Title				
	MS-V271-3.0 (AMD C445->C441)			
Size	Document Number			Re
	om2011-12-14-01

Instruction: Please following table and p appropriate. Please	specify "Polease inse	ARTNER ert a "X" in	SCHEMATIC PAR the "YES" "NO" "N	ot A	UMBER:" on the pplicable" column as llowing table.
			MATIC CHAN		
PARTNER SCHEM				_	
AMD REFERENCE	SCHEMA		_		
Partner schematic pages:	YES	NO	Ontent change of Not Applicable	lesc	Comments
Page 1	X		TOT APPROVATE	1.	Remove SMBus
Page 2		X			
Page 3		X			
Page 4		X

(19) Debug Circuits

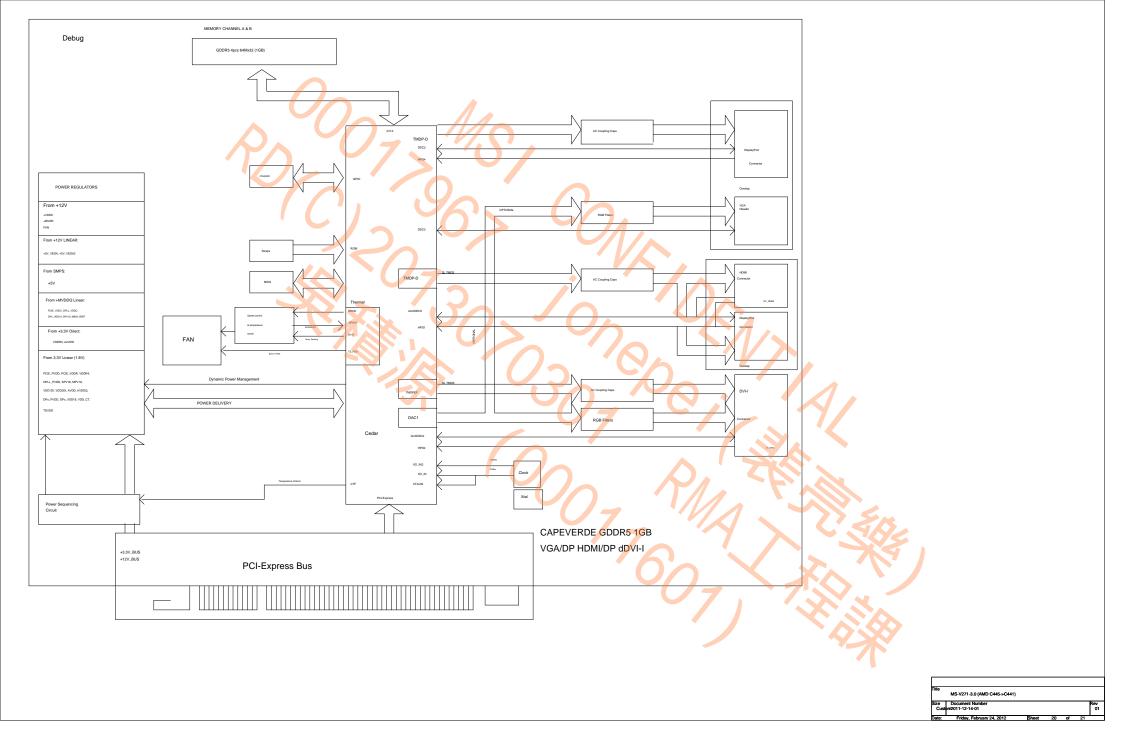
2.	Delete J4004 & relation
Page 19	ı	X		1
